**Economic and Social Council**Distr.: General  
16 January 2019

**1958 Agreement:****Consideration of pending proposals for amendments to existing****UN Regulations submitted by the Working Parties subsidiary to the World Forum****Proposal for Supplement 12 to the 06 series of amendments  
to UN Regulation No. 48 (Installation of lighting and light-  
signalling devices)****Submitted by the Working Party on Lighting and Light-Signalling\*****Revision 2**

## Supplement 12 to the 06 series of amendments to UN Regulation No. 48 (Installation of lighting and light-signalling devices)

Part 5, amend to read:

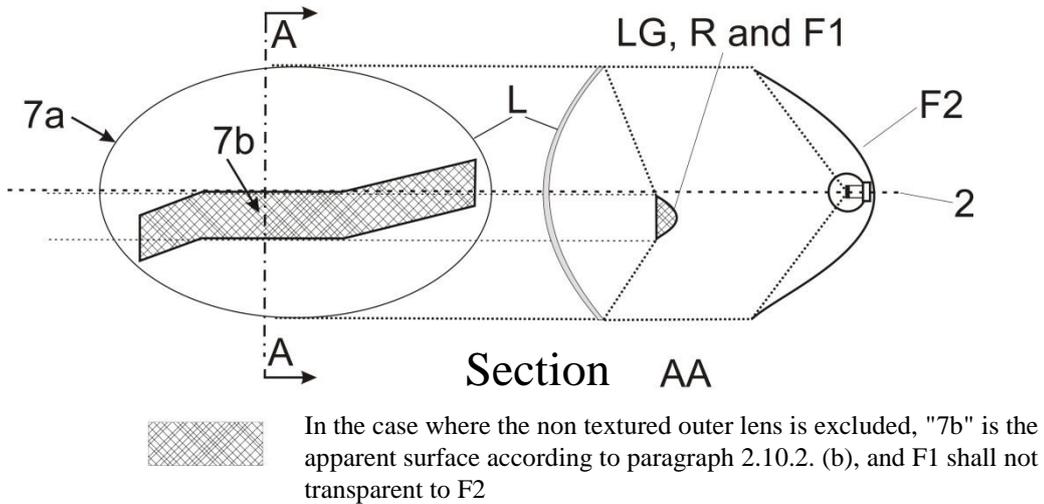
"Part 5 – Example of illuminating surface in comparison with light-emitting surface in the case of a "single function lamp" (see paragraphs 2.10.2. to 2.10.3. of this Regulation)

In the case where the non-textured outer lens is excluded, "7b" is the apparent surface according to paragraph 2.10.2. (b).

Example of a light guide optic or a reflector optic behind an outer lens:

Example 8

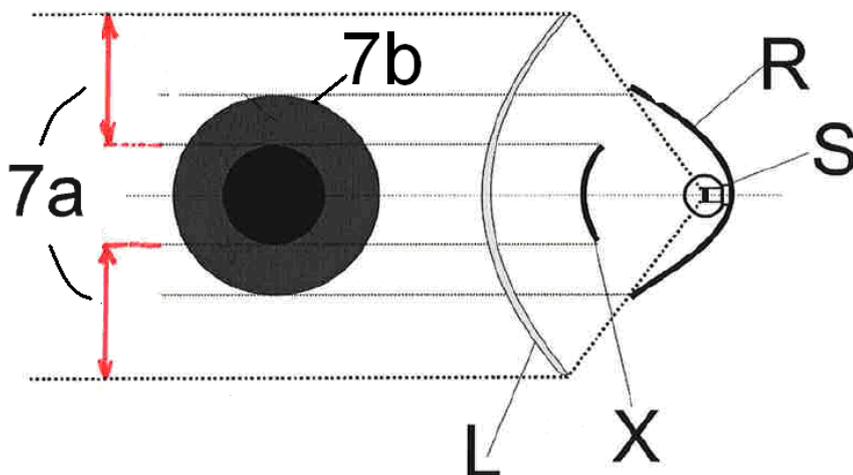
Example of a light source with a reflector optic in combination with an area which is not part of this function, behind an outer lens:

Example 9

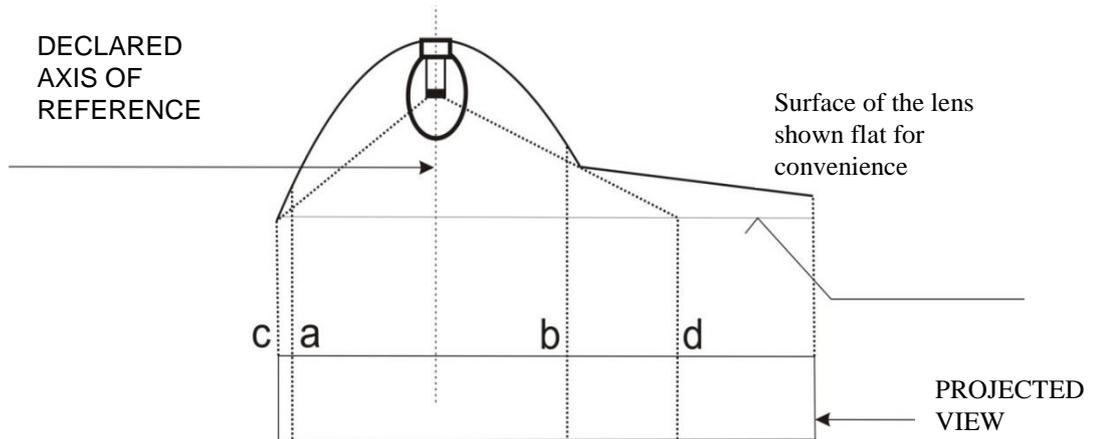
In the case where the non textured outer lens is excluded, "7b" is the apparent surface according to paragraph 2.10.2. (b).

Example A

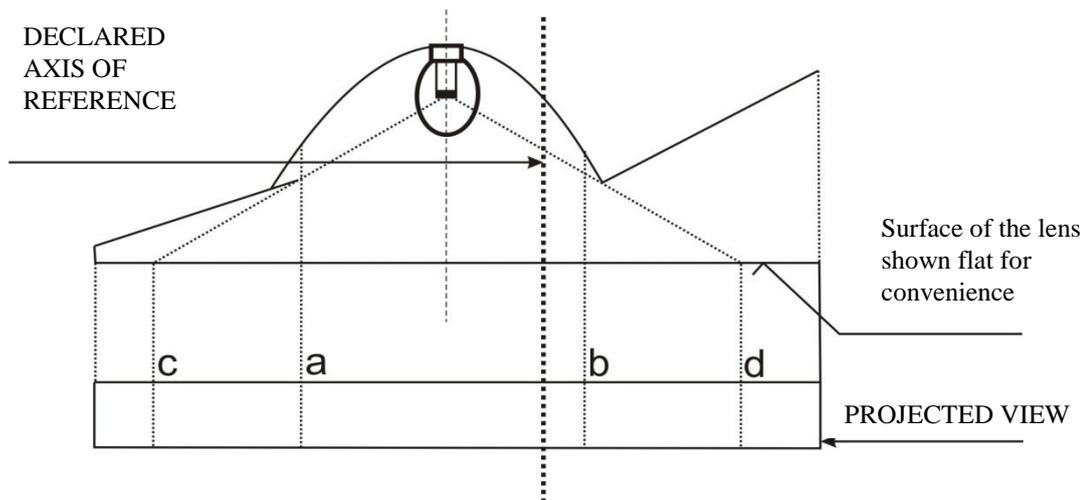
<i>Illuminating surface</i>	<i>Declared light-emitting surface according to 2.10.2. (a)</i>
Edges are	a and b	c and d

Example D

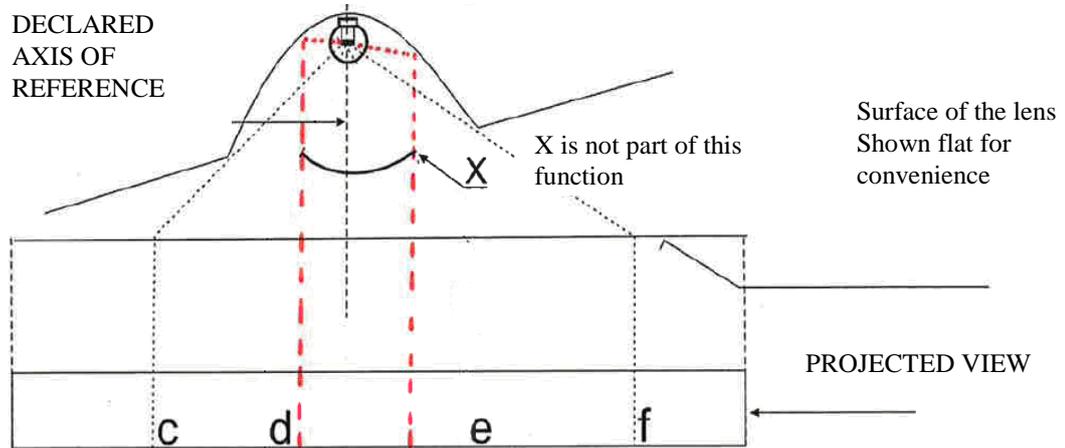
Example to determine a light emitting surface according to 2.10.2. (a) in combination with an area which is not part of the function:

<i>Declared Light-emitting surface according to 2.10.2. (a)</i>
Edges are	c-d and e-f

Example E

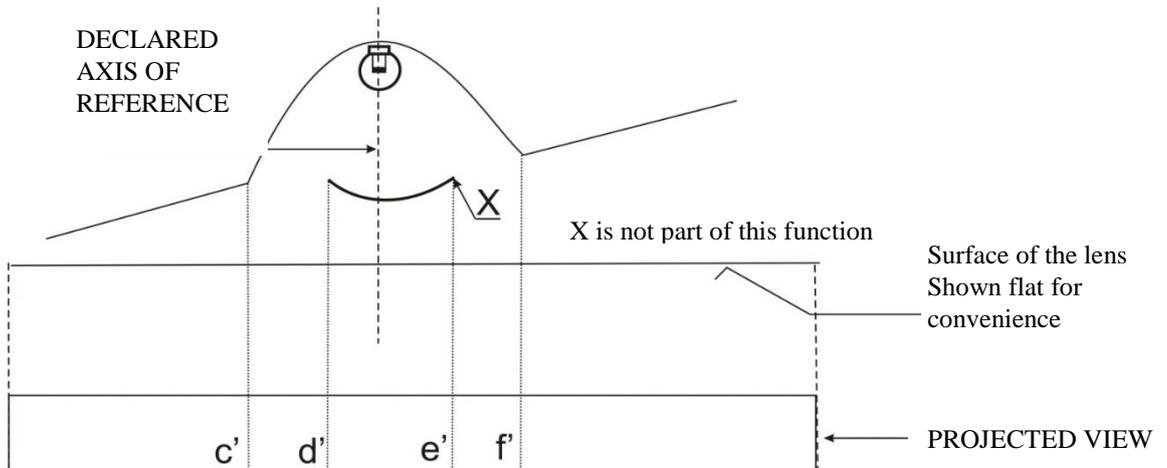
Example to determine the apparent surface in combination with an area which is not part of the function and a non-textured outer lens (according to 2.10.2. (b)):

<i>Declared Light emitting surface according to 2.10.2. (b) for example</i>
Edges are	c'-d' and e'-f'

Part 7, amend to read:

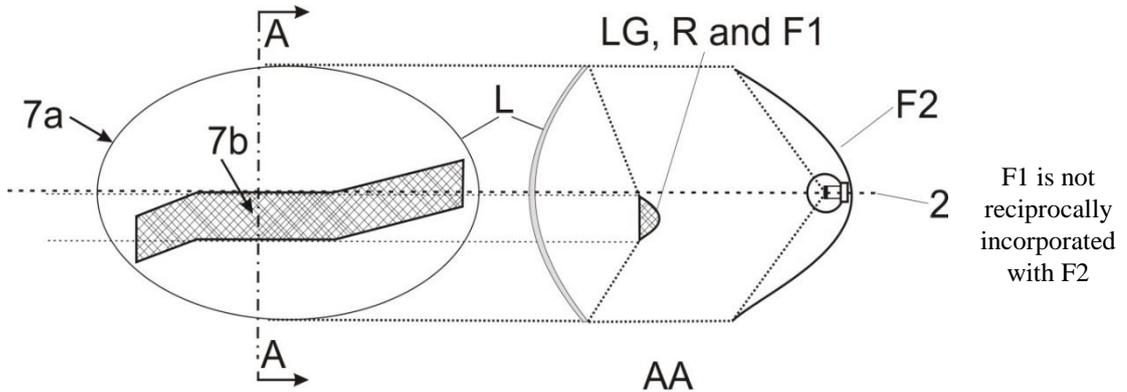
In the case where the non-textured outer lens is excluded, "7b" is the apparent surface according to paragraph 2.10.2. and F1 shall not be transparent to F2:

**Gonio(photo)meter system used for the photometric measurements as defined in paragraph 2.10.9. of this Regulation**

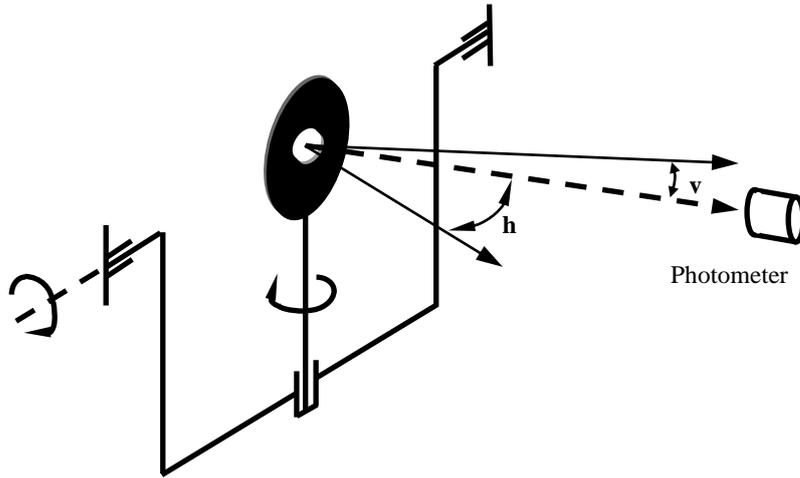
Annex 15, amend to read:
